SERVICE BULLETIN SB03.01

Machines/Models: LX 31/41/50 4WD **Serial Numbers:** 1300-4472

PURPOSE: To assure proper fit of front wheel motor hubs and inspect for possible damage to motor shafts.

FIGURE 1

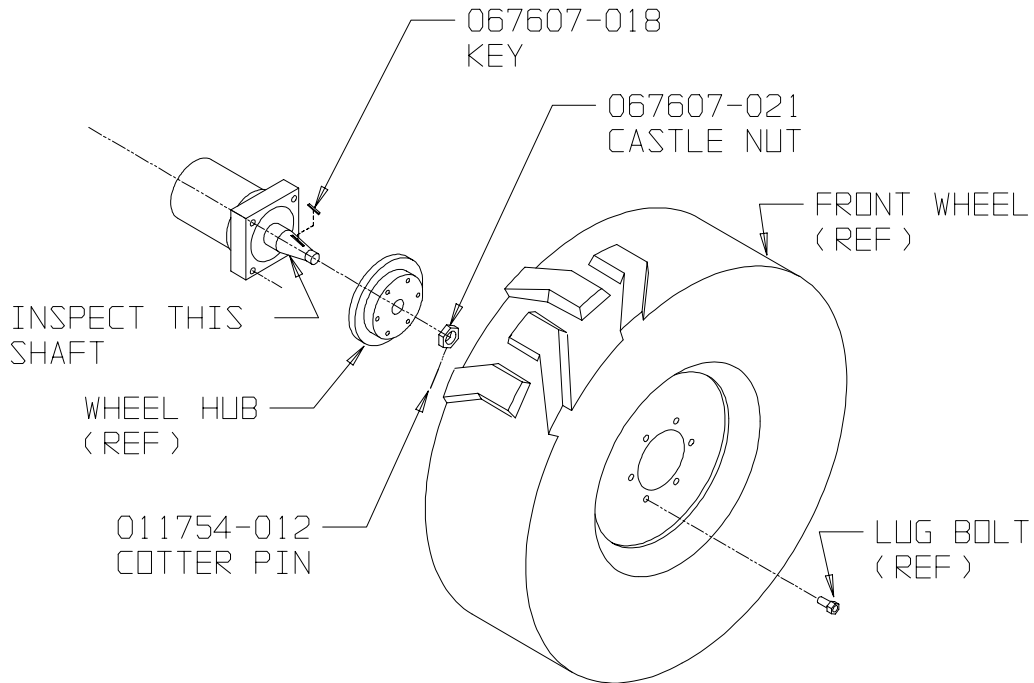
1. Use jack to lift front of machine (steering axle) and support with jack stands.
2. Remove both front wheels and remove hubs from front drive motors. **Figure 1**
3. Discard the original keys, cotter pins, and castle nuts.
4. Clean and inspect motor shafts for deformities or cracks around keyway. **Replace wheel motor shafts if they are cracked or deformed with UpRight part #031044-000 (Kit contains shafts and seals for two motors)**

5. Replace shear keys 067607-018 and install hubs.
6. Install new castle nut 067607-021 and torque to 350 ft lbs. Install cotter pins 011754-012.
7. Reinstall wheels and torque lug bolts to 150 ft lbs.

FIGURE 2

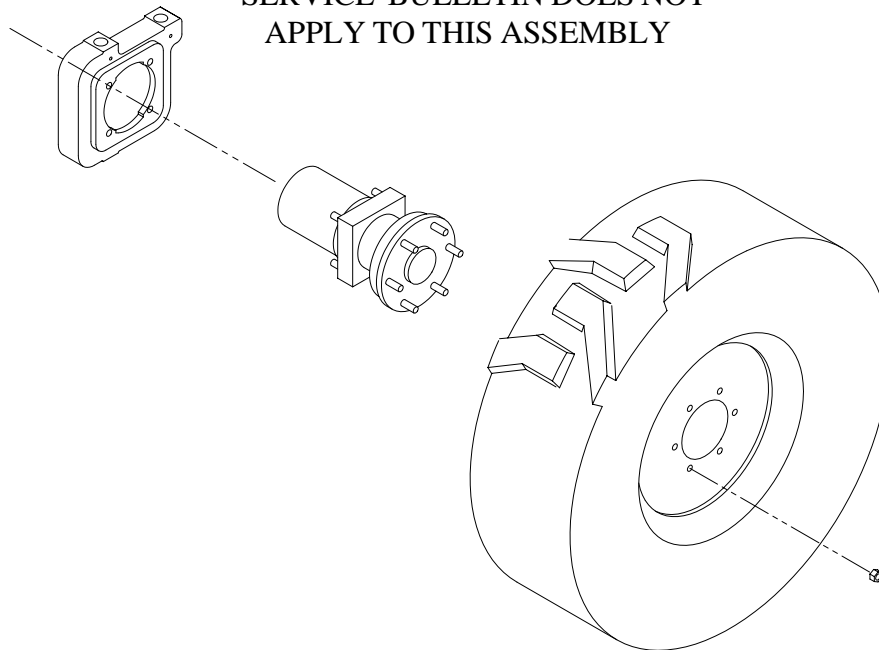
NOTE: Machines with serial numbers before 1300 and some possibly after that number may be equipped with front motors that have integral hubs. **(see figure 2)** These units will not have a castle nut on the hub. If machine is equipped with an integral hub disregard this bulletin.

**SERVICE BULLETIN DOES NOT
APPLY TO THIS ASSEMBLY**
